UNITED STATES ENVIRONMENTAL PROTECTION AGENCY
WASHINGTON, D.C. 20460

November 17, 2021

EPA’s Reconsideration of its November 30, 2020 Letter Regarding the Applicability of its 2008 Clean Water Act Section 404(c) Final Determination for the Yazoo Pumps Project to the 2020 Yazoo Pumps Project

Figure 2. Plate 4-1 from the 2007 FSEIS, Project Location and Vicinity Map.

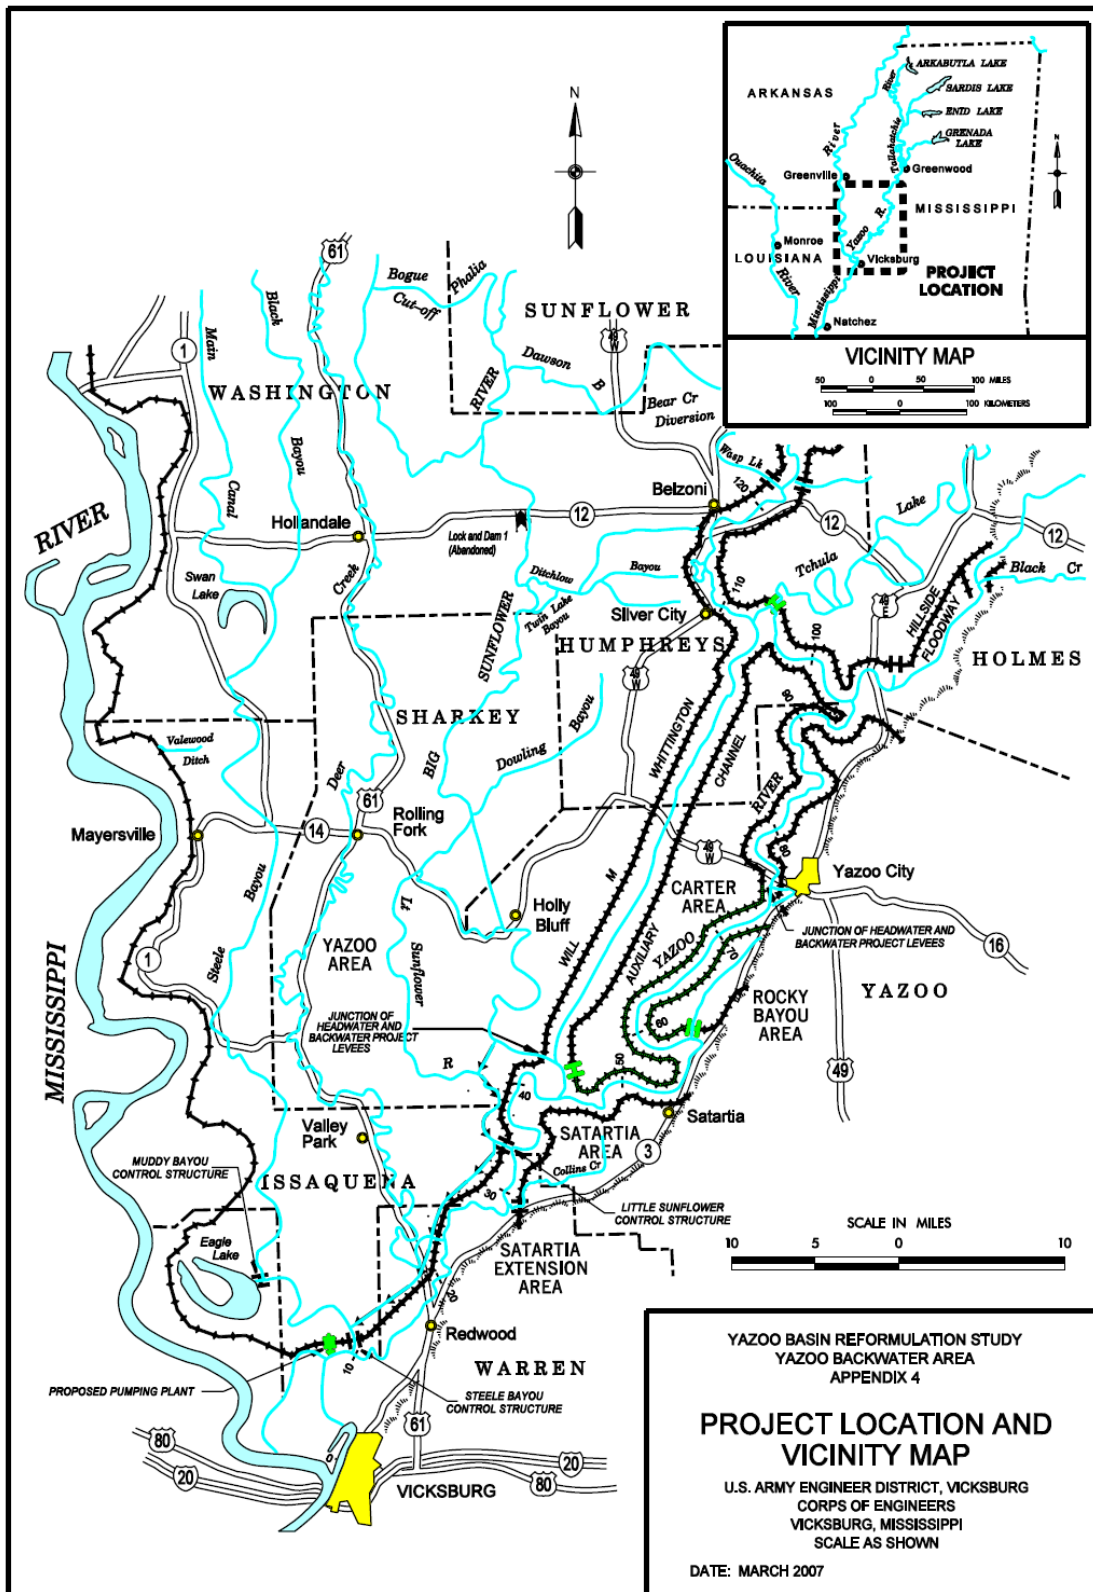
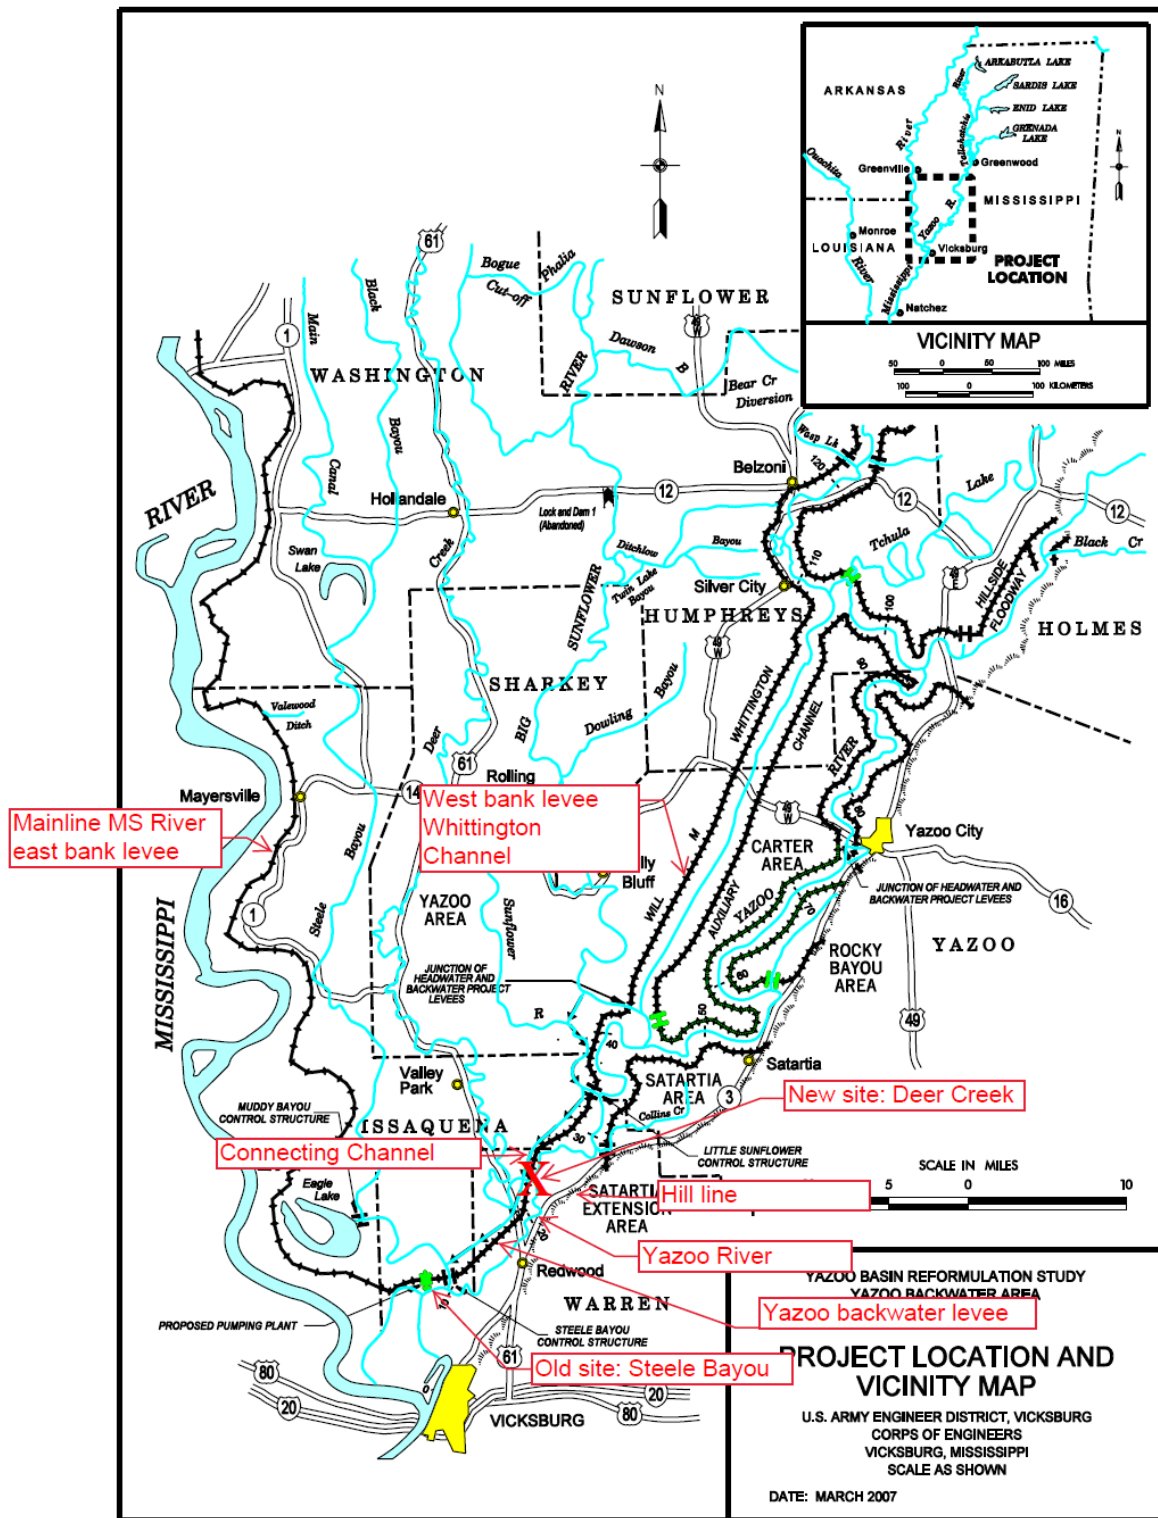
Finally, EPA assessed whether the discharges of dredged and fill material from the 2020 Project fall within the boundaries of the Yazoo Backwater Project Area delineated by the Corps in the 2007 FSEIS. The answer is clearly yes.

As noted above, Figure 2 below is a reprint of 2007 FSEIS Plate 4-1, which the Corps identified as the Yazoo Backwater Project Area in the 2007 FSEIS. Figure 3, below, is Plate 4-1 annotated by EPA to identify the proposed locations of the Steele Bayou and Deer Creek pumping stations as well as features identified in the description of the boundary of the Yazoo Backwater Project Area that are relevant for determining whether the Deer Creek pump location is within the boundary of the Yazoo Backwater Project Area. As demonstrated by Figure 3, the proposed Deer Creek pumping station location falls within the triangular shaped Yazoo Backwater Project Area that has an eastern boundary demarcated by the hill line, a western boundary demarcated by the Mainline MS River east bank levee, and a northern boundary demarcated by the latitude of Hollandale and Belzoni, MS.

Figure 4a shows the jurisdictional wetland determination of the pump station which includes pump station footprint, pump station right-of-way (ROW), access road ROW, and utility ROW. This is a reprint of Figure 7 from 2020 FSEIS Appendix L, CWA Section 404(b)(1) Evaluation.

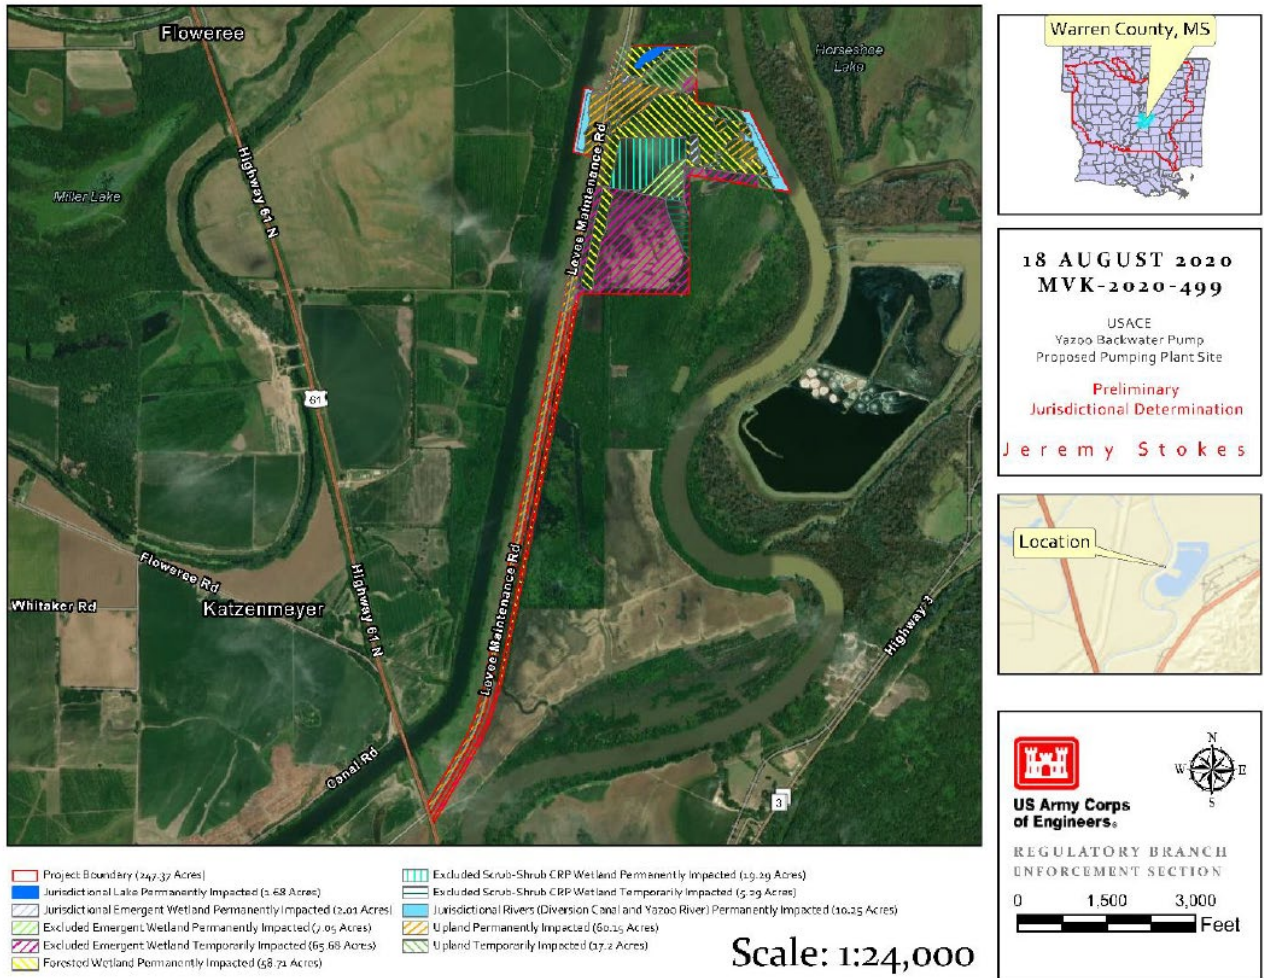
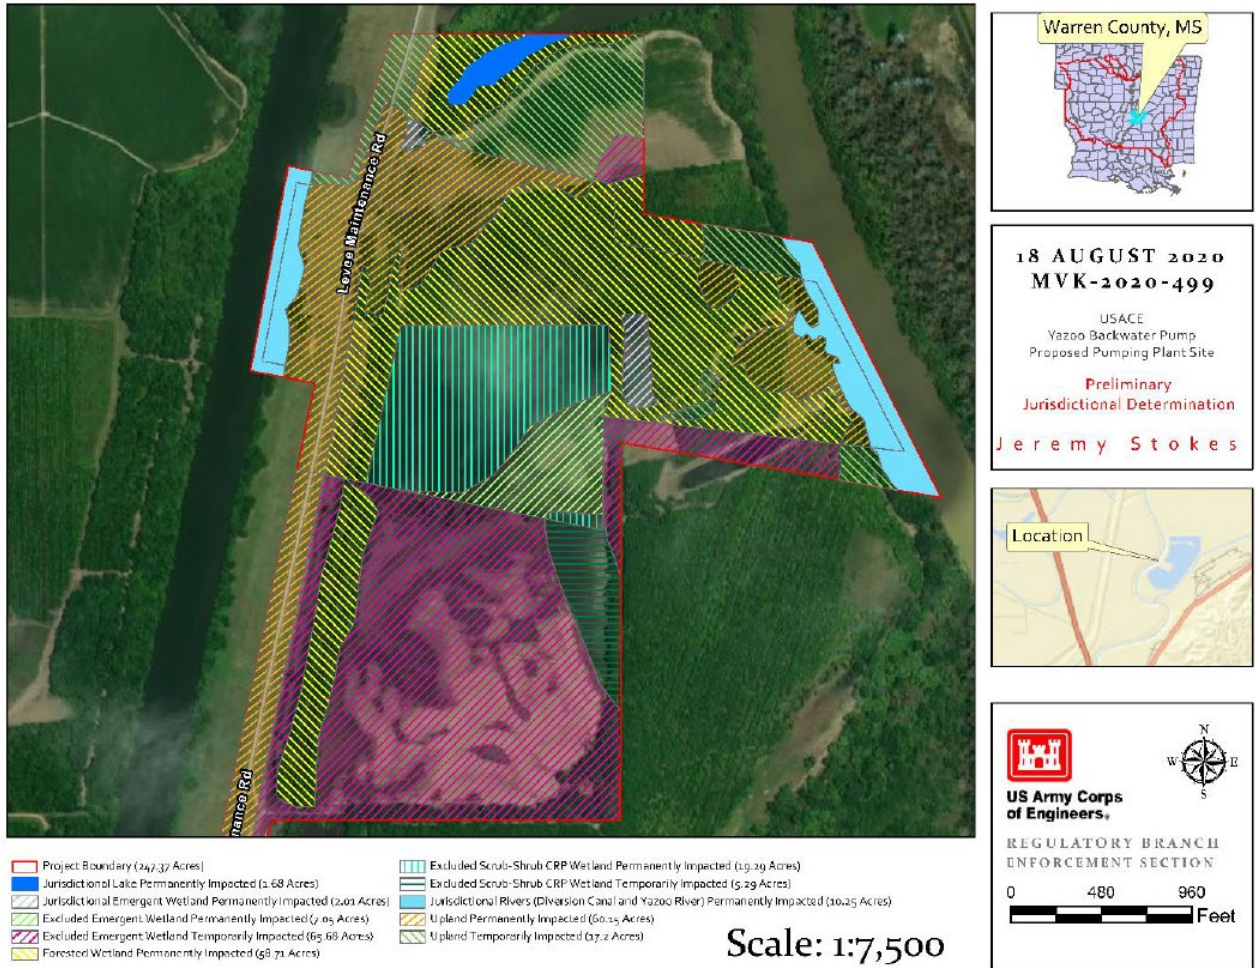
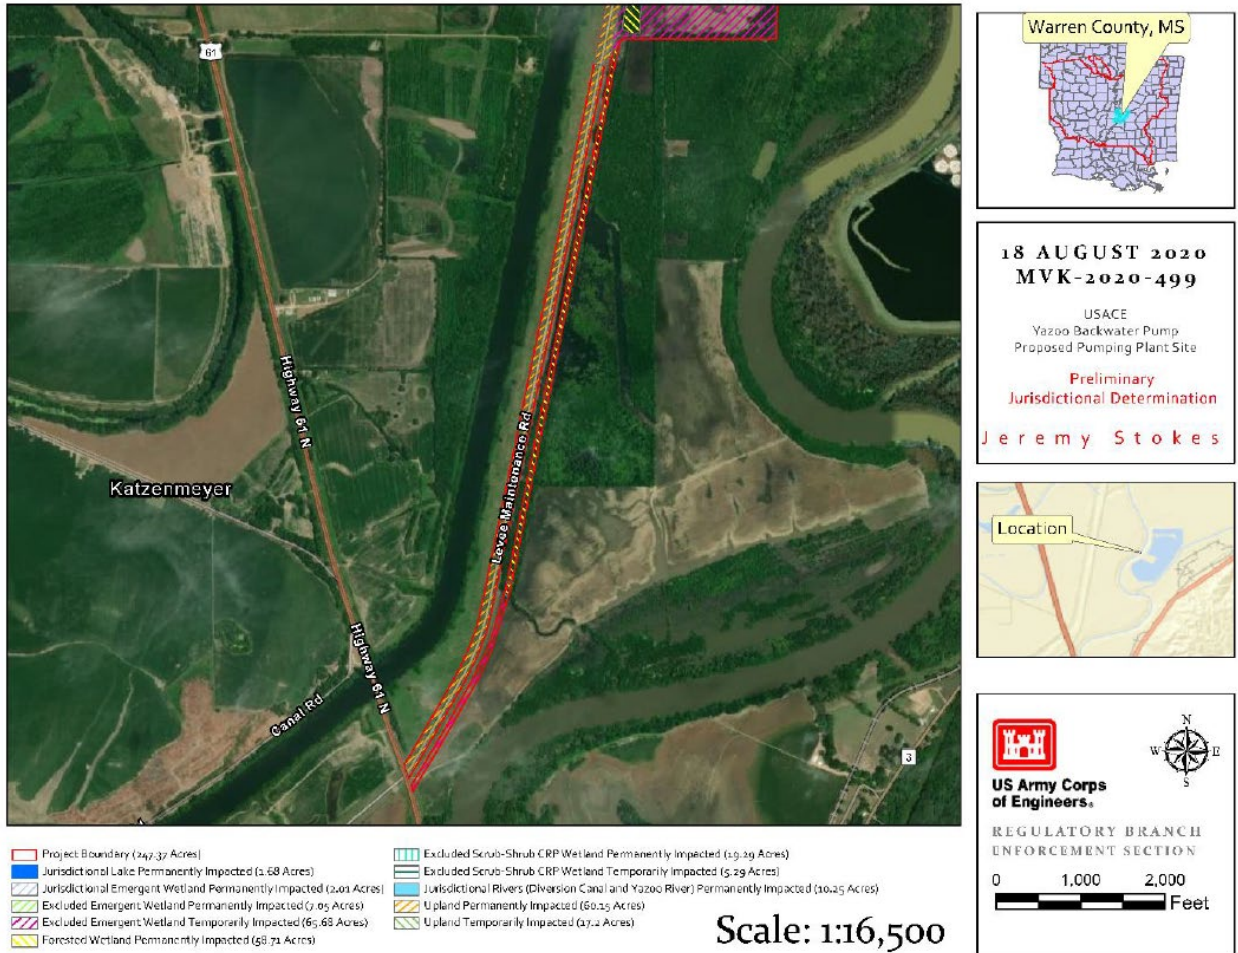
Furthermore, Figures 4a-d, below, which are reprints of Figures 7-10 from Appendix L (CWA Section 404(b)(1) Evaluation) of the 2020 FSEIS provide further confirmation that all the discharges associated with constructing the 2020 Plan fall within the Yazoo Backwater Project Area. Figure 4a shows the proposed Deer Creek pumping station location. The footprint of the pump station is situated between the connecting channel and the Yazoo River, an area that clearly falls within the larger triangular shaped Yazoo Backwater Project Area described above. Figure 4b shows a close-up of the pump station footprint with discharges identified by blue shading in the connecting channel on the west and the Yazoo River on the east. Figure 4c identifies the footprint of the access road to the proposed Deer Creek pumping station location. The access road footprint is also situated between the connecting channel and the Yazoo River, which is also within the larger triangular shaped Yazoo Backwater Project Area. Figure 4d shows the footprint for the proposed borrow area and the proposed access road to the borrow area. These are adjacent to the proposed Steele Bayou pump site location, an area that also clearly falls within the larger triangular shaped Yazoo Backwater Project Area.²³
